REQUEST

SUMMARY OF PETITION

The petition proposes to allow for the redevelopment and expansion of the existing Panthers’ Practice Facilities and associated accessory uses.

PLANNING STAFF REVIEW

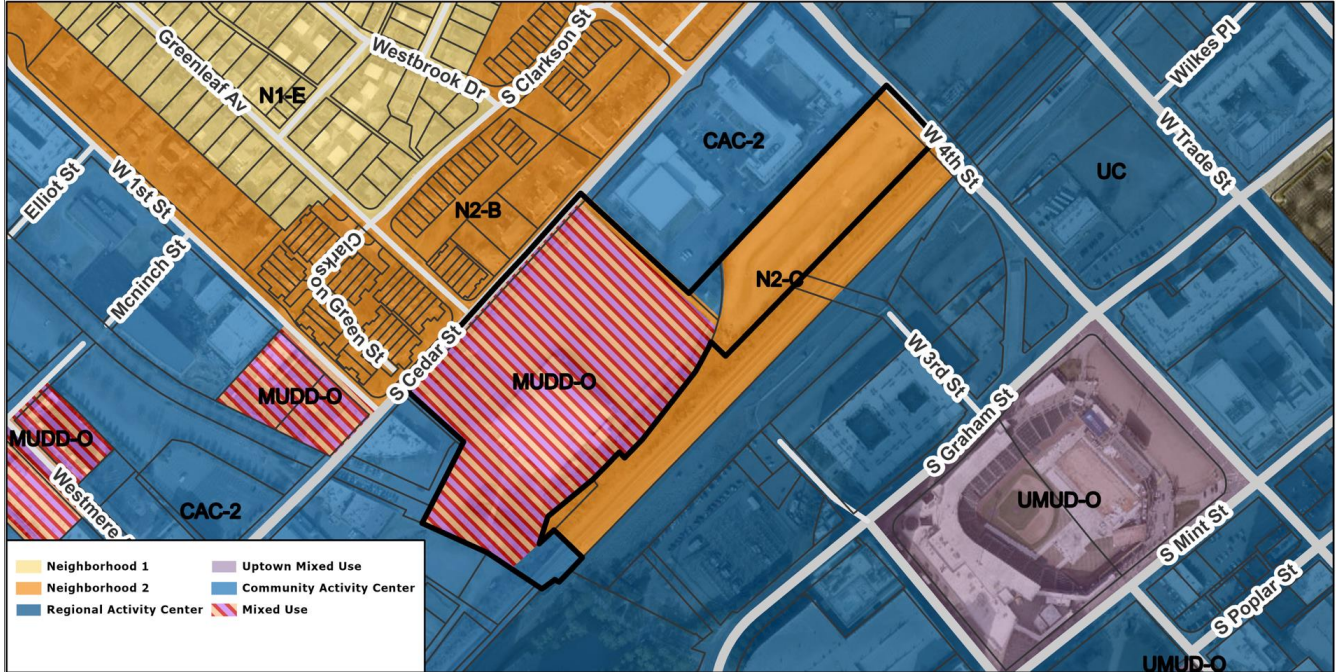
1. Add a conditional note specifying "A Right-of-Way Encroachment Agreement is required for the installation of any non-standard item(s) (irrigation systems, decorative concrete pavement, brick pavers, etc.) within a proposed/existing City-maintained street right-of-way by a private individual, group, business, or homeowner's/business association. An encroachment agreement must be approved by CDOT prior to construction/installation. Contact CDOT for additional information concerning cost, submittal, and liability insurance coverage requirements."

2. Add a conditional note specifying "the Petitioner shall dedicate and convey in fee simple all rights-of-way to the City before the site's first building certificate of occupancy is issued. CDOT requests rights-of-way set at 2' behind back of sidewalk where feasible."

3. Add a conditional note specifying "All transportation improvements will be approved and constructed before the site's first building certificate of occupancy is issued."

4. Revise the proposed EX benefits to list what city improvement, public amenity, or sustainability measure is being provided with details such as which streetscape improvements are being provided that exceed ordinance standards and the square footage, location, and features of the public open space. Add a conditional note stating that the proposed public benefits in this rezoning may not be used to satisfy any public benefit requirements for future rezonings.
5. Remove notes B and C under the EX provisions that notes which standards can be modified through an EX request since the language incorrectly references standards that cannot be modified with an EX request.

6. Add a proposed maximum building height for Development Area B.
7. Add details clarifying which proposed standards may be met on the stadium portion of the property in explicit and clear language.

8. Clarify if the EX provision for Article 12.3 regarding minimum building length standards is being sought for all frontages.
9. Clarify if the EX provision for Article 12.3 regarding transparency standards is being sought for all frontages.

10. Remove the EX provision for Article 16.2 regarding exterior lighting if no modifications to the zoning standards are proposed.
11. Modify the EX provision for Article 19.3 to propose a new maximum distance from the entrance where the bicycle parking will occur.

12. Modify the EX provision for Article 19.6 regarding the design of surface parking and parking lots. As written, the standard being modified is not a quantifiable standard nor is the proposed modification quantifiable.

13. Remove the EX provision for Article 19.7 regarding the design of parking structures as this is not a quantifiable zoning standard that can be modified through EX.

14. Add typical cross sections for rideshare areas that would be expected along South Cedar Street and West Fourth Street.
15. Modify the EX provisions for Article 22 and section 4 of the conditional notes to remove all language except that which references a master signage package and the commitment to not orient signage towards the residential uses along Cedar Street.

16. Modify the EX Provision for Articles 20, 15, and 17 regarding green area percentage requirements in accordance with guidance from Urban Forestry. What is considered built-upon-area must comply with the ordinance.
17. Work with Urban Forestry to provide the required tree survey.
